Reference: 21/02622/FUL
Application Received Wed 19 May 2021
Application Validated Wed 19 May 2021

Address 75 Shirley Avenue Croydon CR0 8SP

Proposal Conversion of and extension to existing dwelling to

provide four self-contained flats.

<u>Fig 1 – Google Earth Image showing 75 Shirley Avenue is over 800m</u> <u>from a Train/Tram Station and over 800m from a District Centre.</u>

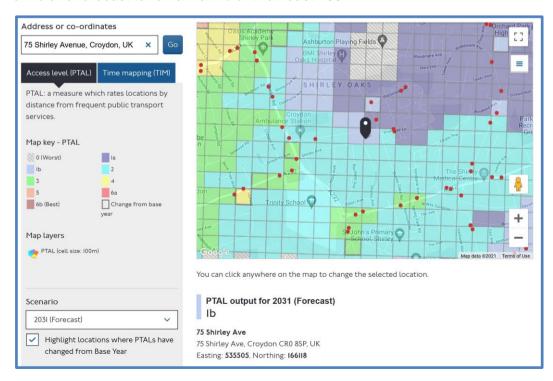
- 4.2 The Google Earth image (above) illustrates the development site for this proposed development at 75 Shirley Avenue which has Public Transport Accessibility Level (PTAL) of 1b and is greater than 800m radius from any Train Station or Tram Stop and over 800m (Line of Sight) from any District Centre and therefore the locality is NOT appropriate for "Incremental Intensification" as defined by the London Plan. The Shirley Shopping Parades are 'Local' Centre, not 'District' Centres.

<u>Histogram 2 - Showing Comparisons of Residential & Housing Densities with</u>
<u>the existing and Shirley North Ward Average Population Densities</u>

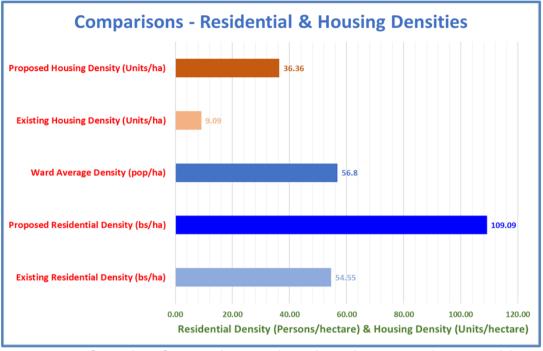
6.10 At occupancy of 12 persons on a site area of 0.11ha gives an increase density of 92% above the average Density of 56.8 persons per hectare for the Shirley North Ward at PTAL of 1b and forecast to remain at 1b up to 2031.

Histogram 1 – Incremental increase in Density of this proposed development with Site

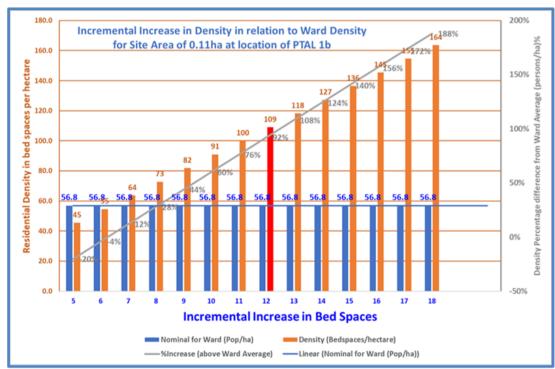
This is significantly greater than any interpretation of "Incremental Intensification" or "Gentle Densification" allowed under London Plan Policy para 4.2.4. Where on the Graph at Histogram 1 is the appropriate "Gentle Densification" or "Incremental Intensification" density point or range for this suburban site area of 0.11ha and PTAL at 1b?

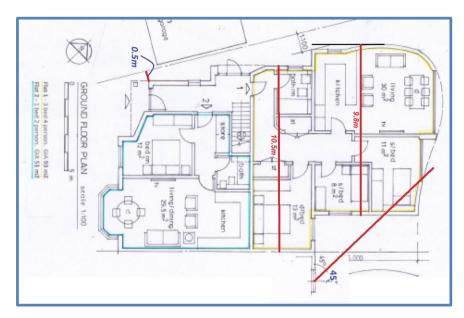
7.2 Although the proposed development meets the 45° Rule (Horizontal) SPD2 para 4.16 at First Floor Level, the development fails this 45° rule at Ground Floor level as shown in the following illustration.

As this is NOT shown on the supplied Plans, it may be that there is no Habitable Room Window at ground floor level of the adjacent property but is of concern enough to raise with the Case Officer for clarification.
